ADDENDUM NO. 1

REYNOLDSBURG CITY SCHOOLS
L.F.O. ATHLETIC & ECO LAB PROJECTS

Date: March 25, 2011

Addendum No. 1 to the Drawings and Project Manual, dated **March 17, 2011**, for **L.F.O. ATHLETIC & ECO LAB PROJECTS**, Reynoldsburg City Schools, 7244 East Main Street, Reynoldsburg, Ohio 43068; as prepared by Moody Nolan, Inc., 300 Spruce St. Suite 300, Columbus, OH 43215.

FIRST FLOOR PLANSOUTH
CONCESSION & RESTRM BLDG - LINGSTON AVE

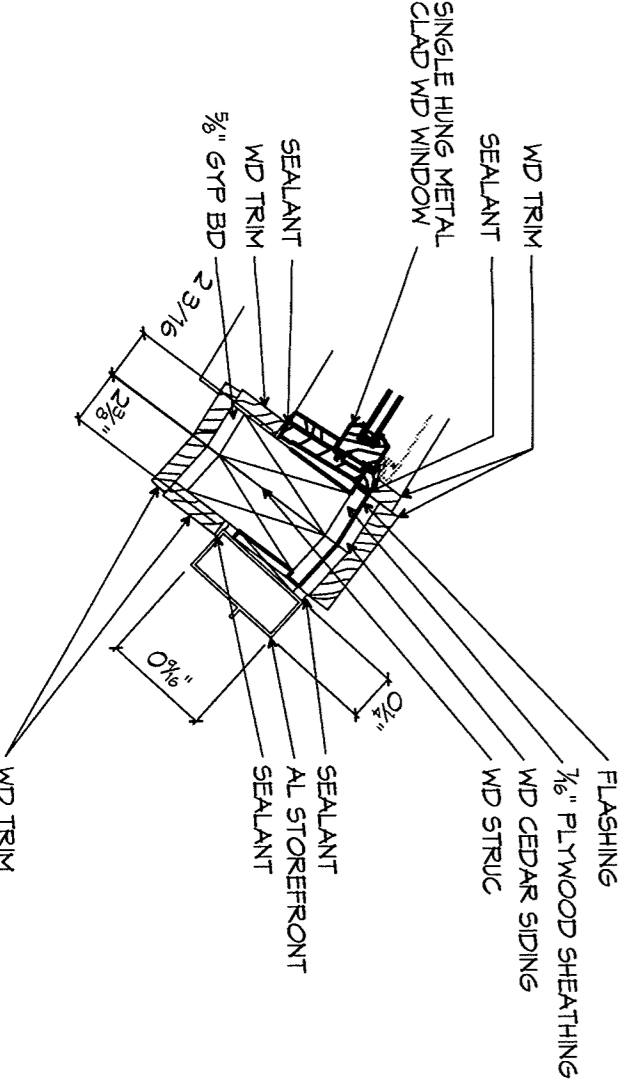
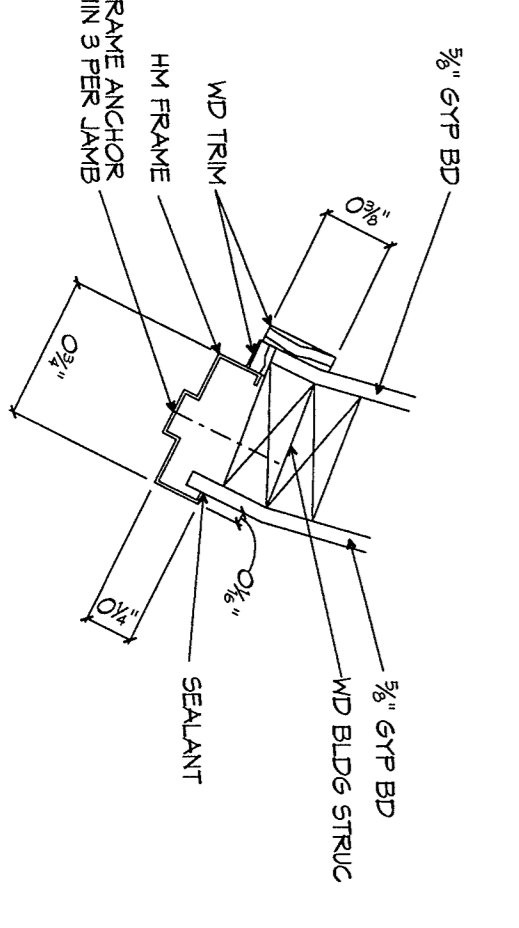
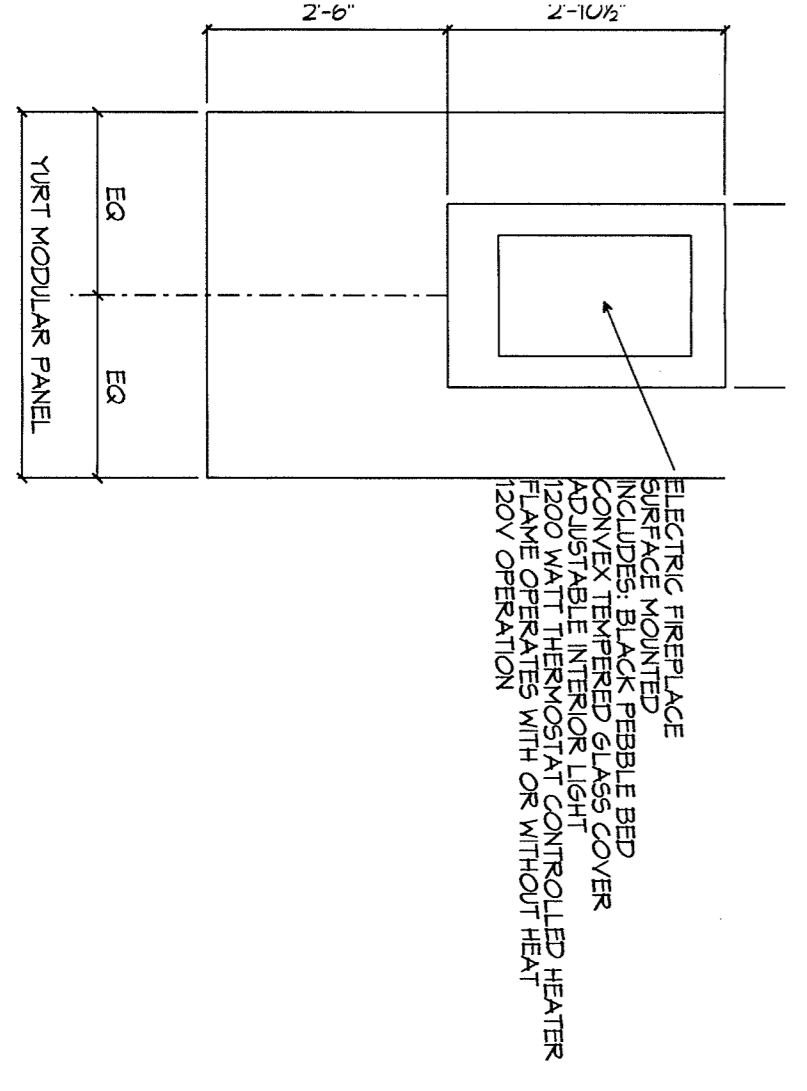
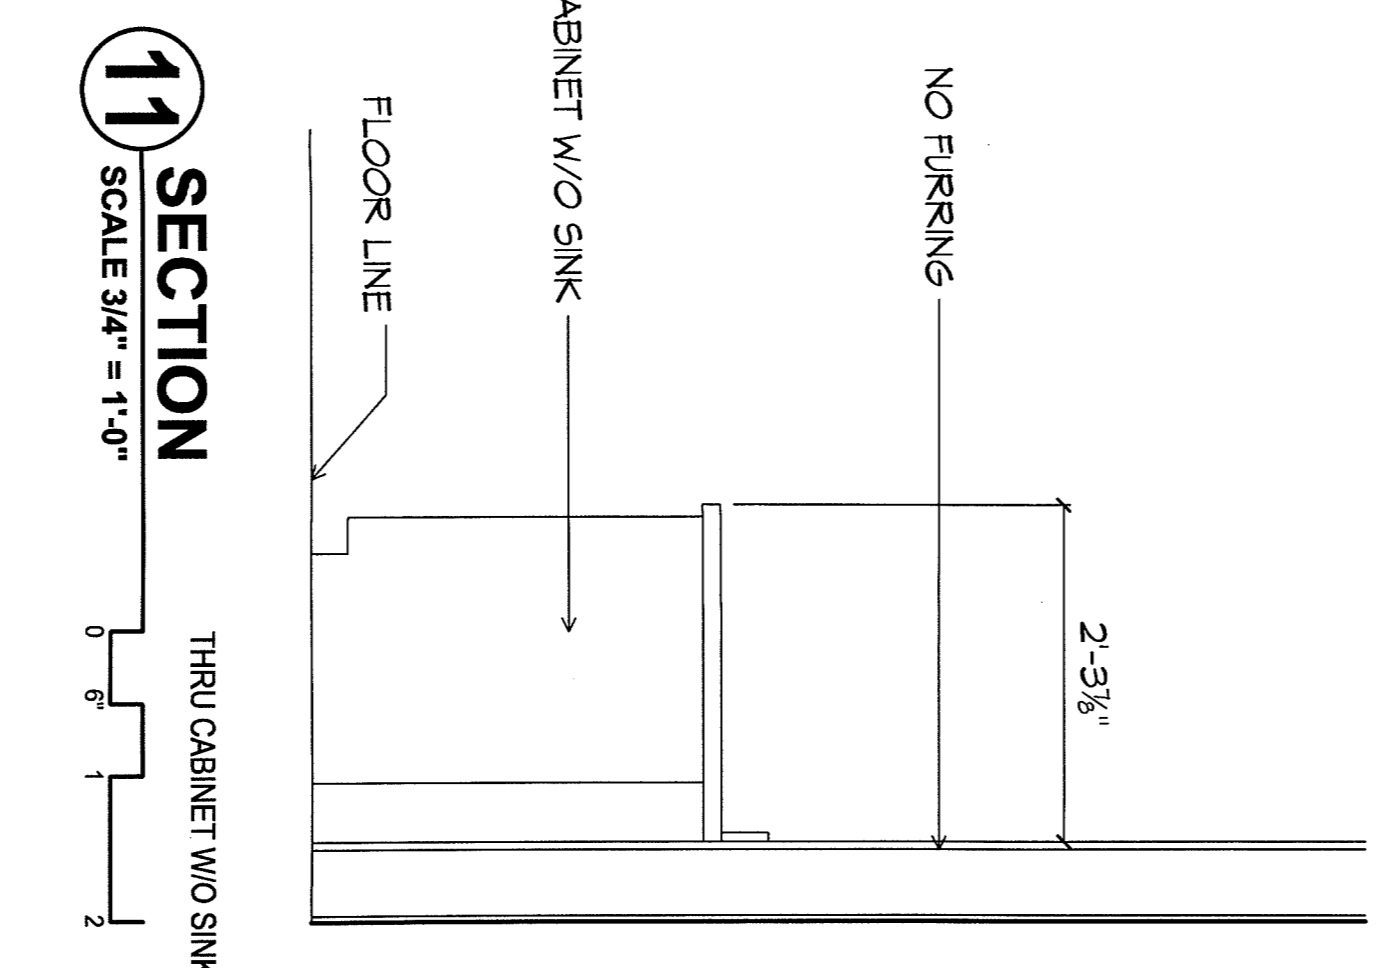
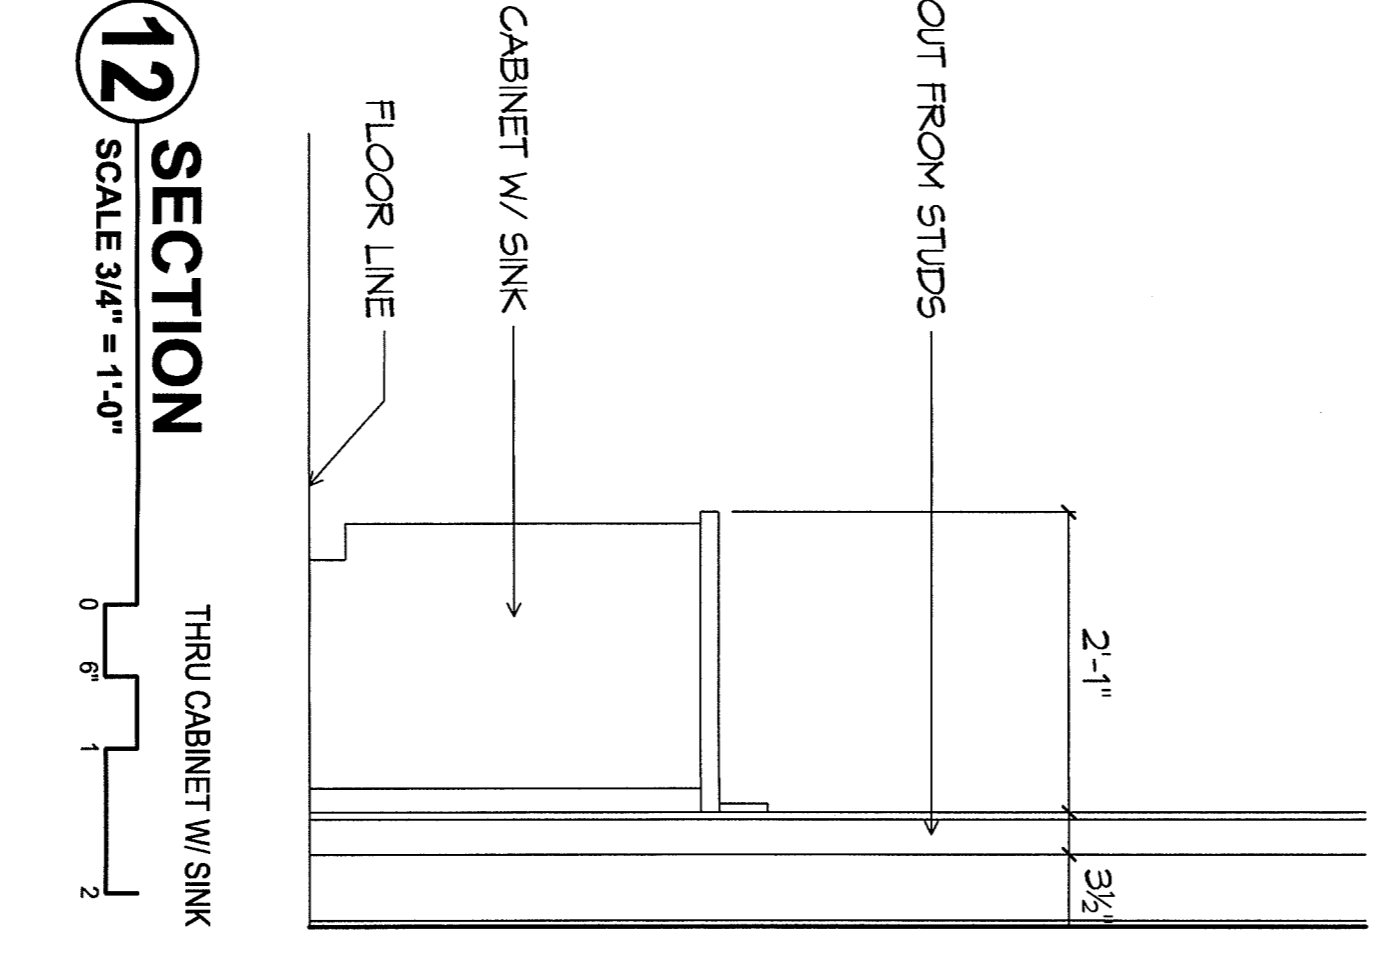
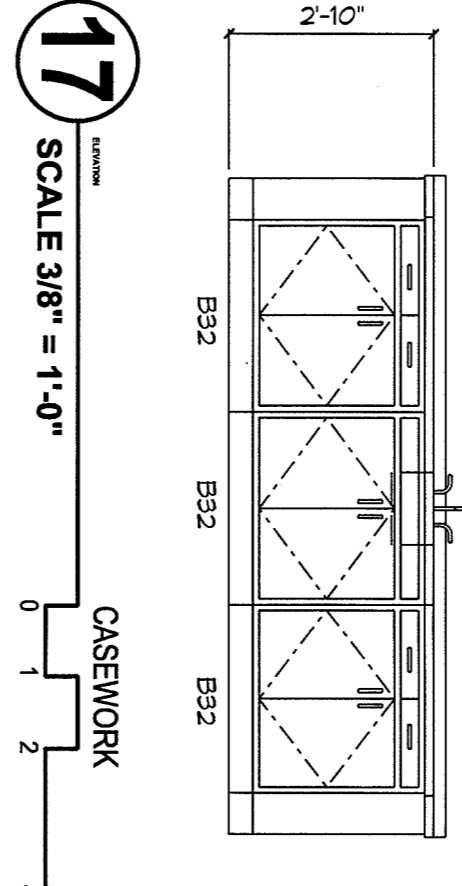
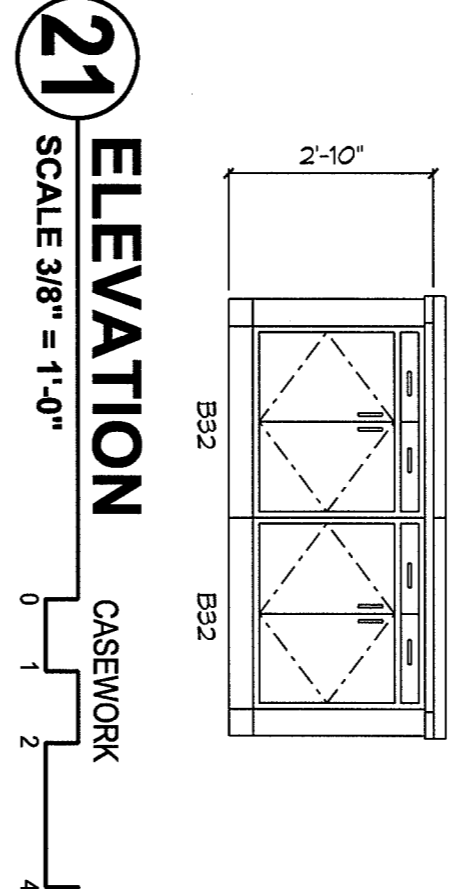
- Item 1-7 Vol. 1, SHEET Aa1.1
A. **RE-ISSUE:** See clouded revisions. Plan legend revised to be similar on all sheets.
- Item 1-8 Vol. 1, SHEET Aa2.1
A. **DELETE:** Remove a106a door reference from RCP Plan 1.

ISSUED WITH ADDENDUM 1	SHEET REVISED X1.2
SKETCH NUMBER A-SK01	
PROJ # 08177.1	DRAWN BY DBW
DATE 3/25/11

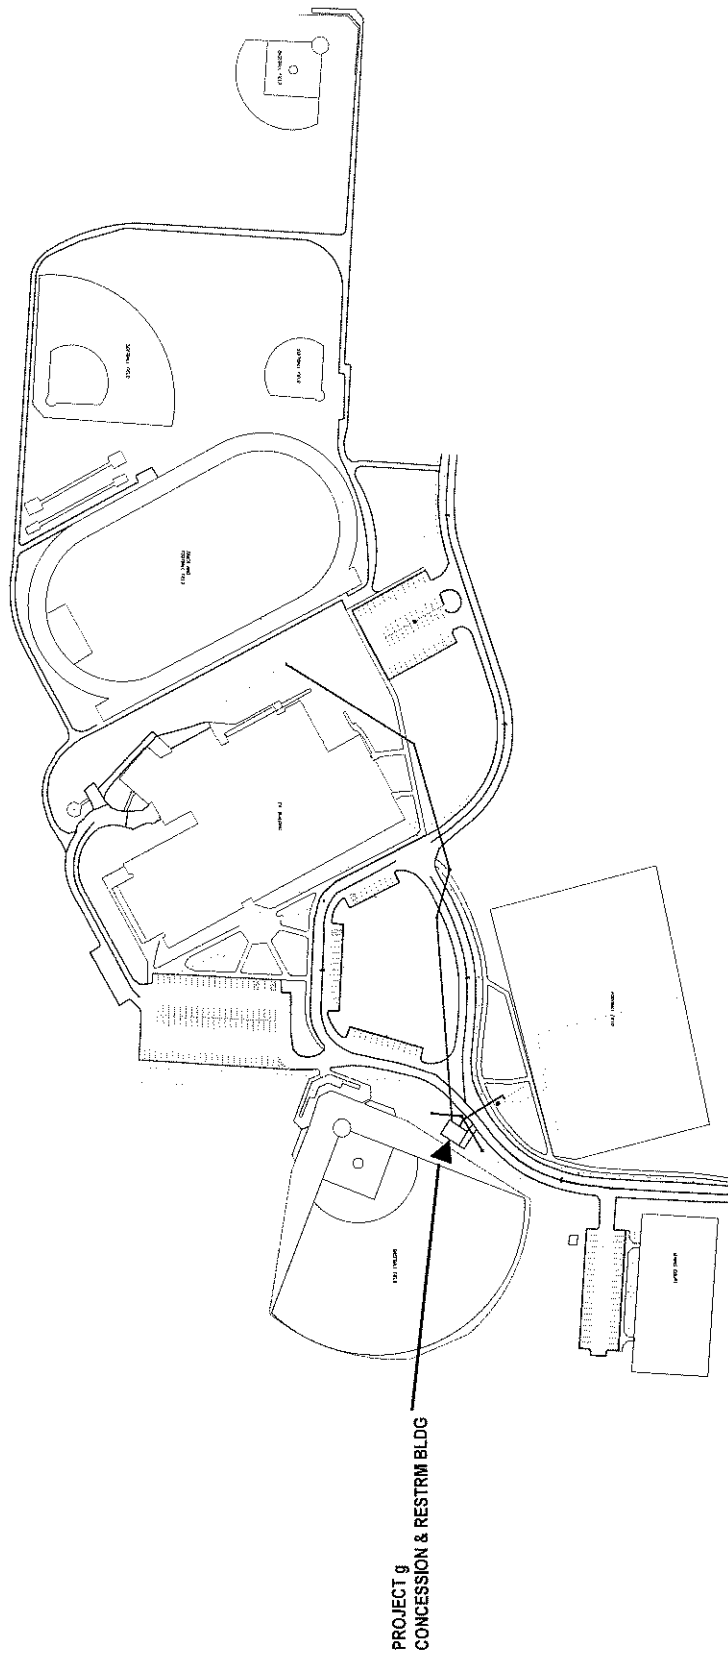
- Item 1-5 Vol. 1, SHEET X1.2
A. **ADD:** BALDWIN ROAD SITE PLAN, see A-SK01.
- Item 1-6 Vol. 1, SHEET Xa1X
A. **REVISE in Sub Index of Drawings – Volume 1:** Sheet titles Xa1X, T0.01 and T0.02 to match the sheet titles in each corresponding border. Sheets Pa1.11 and Pa1.11F sheet order exchanged.

1 SECTION
 THRU CONCESSION
 SCALE 1/4" = 1'-0"

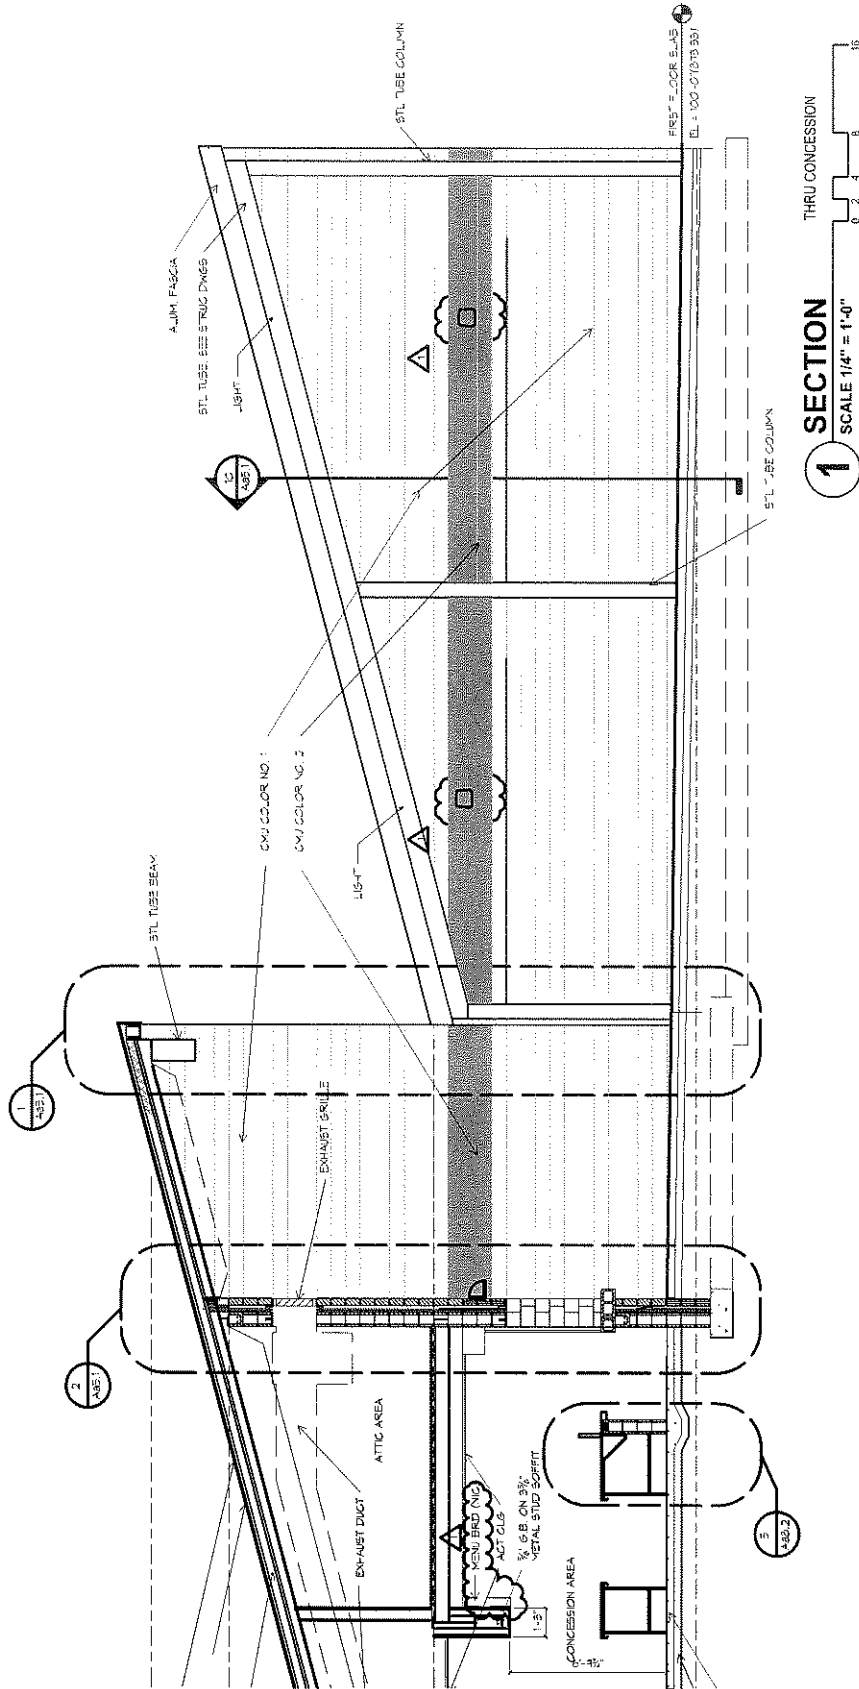
- Item 1-17 Vol. 1, SHEET Aa4.1
A. **REVISE:** Section 1, added menu board NIC and revised 2 exterior fixture locations, see A-SK03.
- Item 1-18 Vol. 1, SHEET Aa7.1
